Memorandum

Subject: Responses to Comments

TECHNICAL MEMORANDUM
Napa River Salt Marsh Restoration Project

Subject: *Alternative Bittern Removal for Pond 7 Salinity Reduction – Conceptual Cost Estimate*

Figure 2-2
Existing Conditions

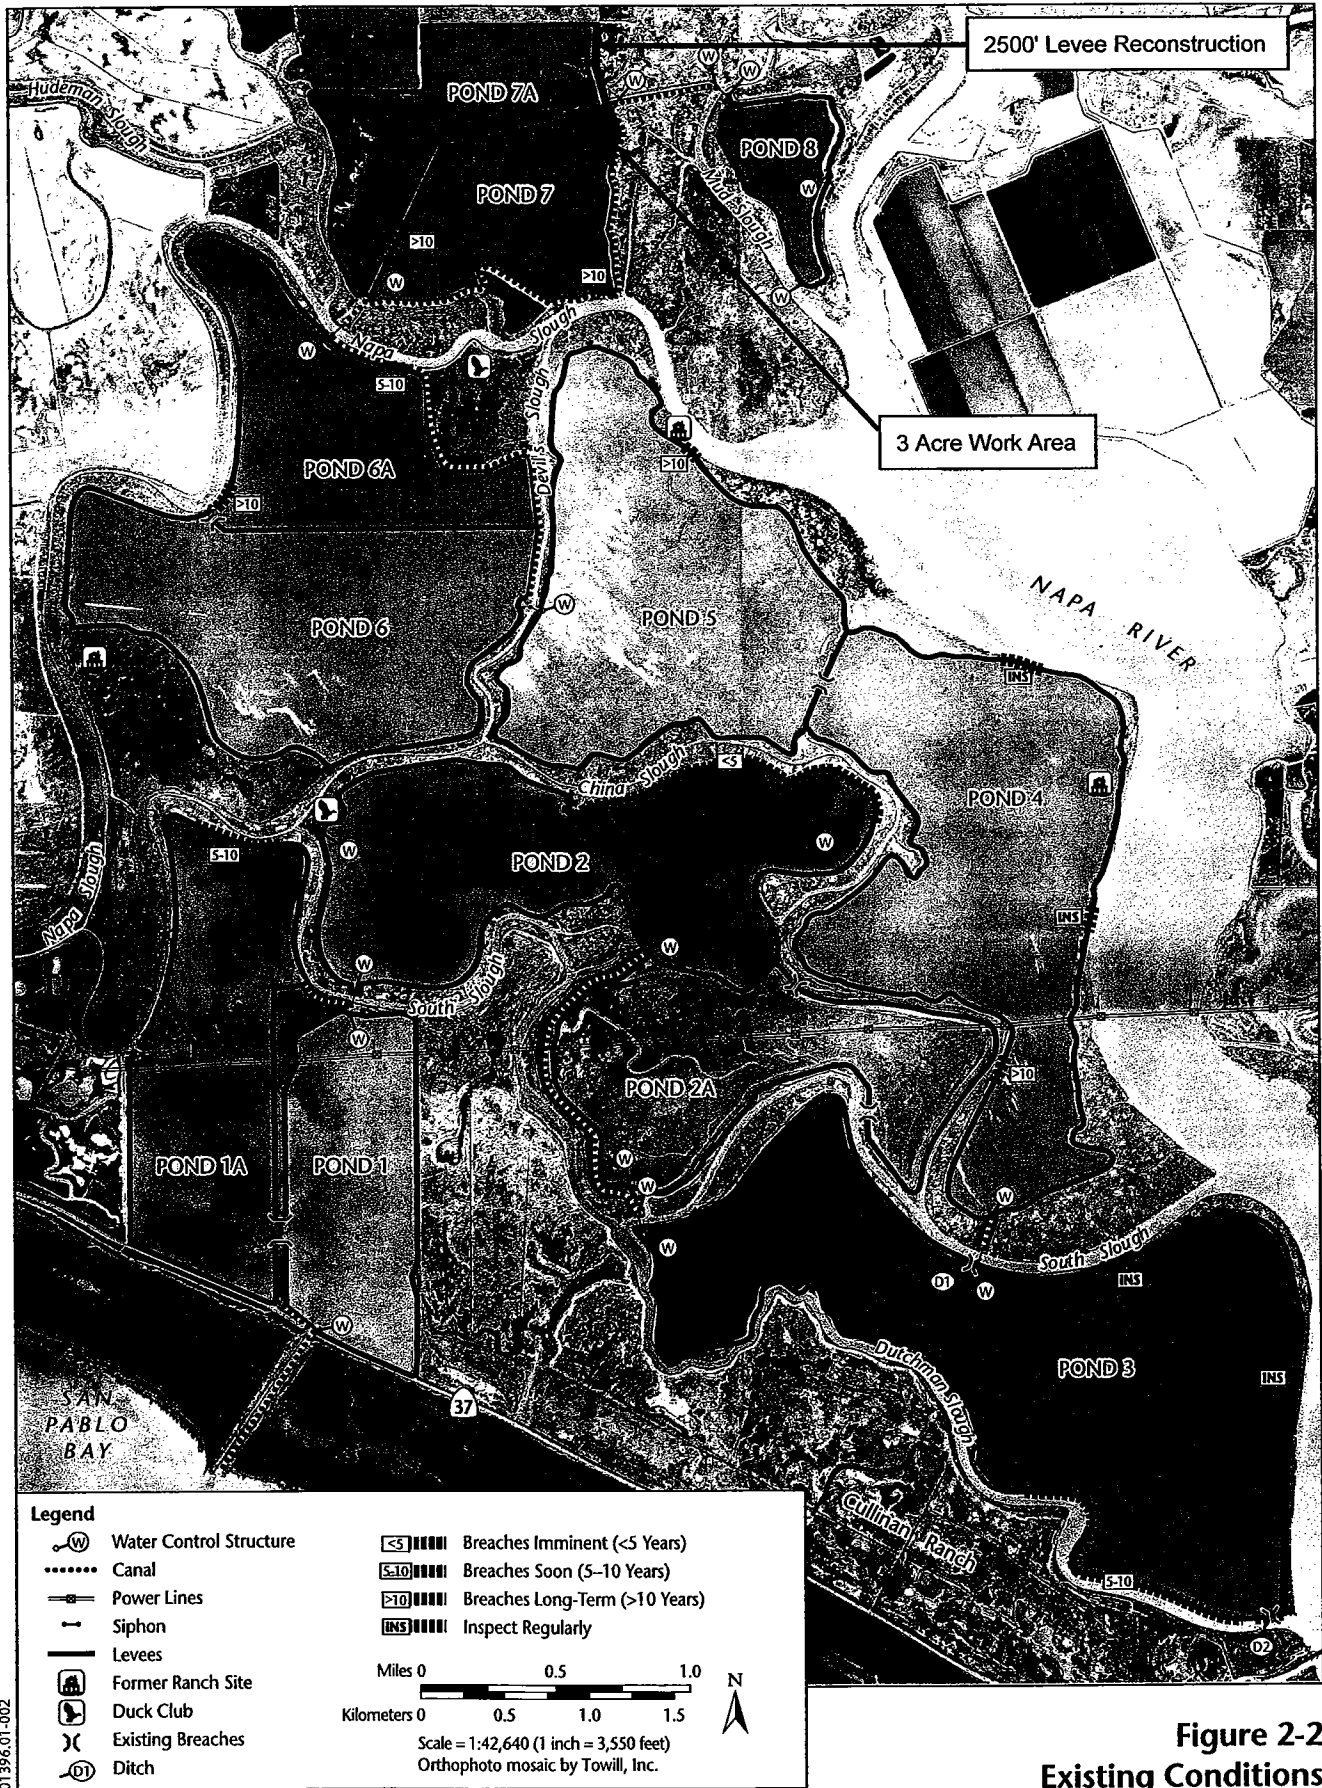
- b. A description of the alternative components is included in the revised memorandum. Markups to Figure 2-2 from the Draft EIR/EIS are also included.
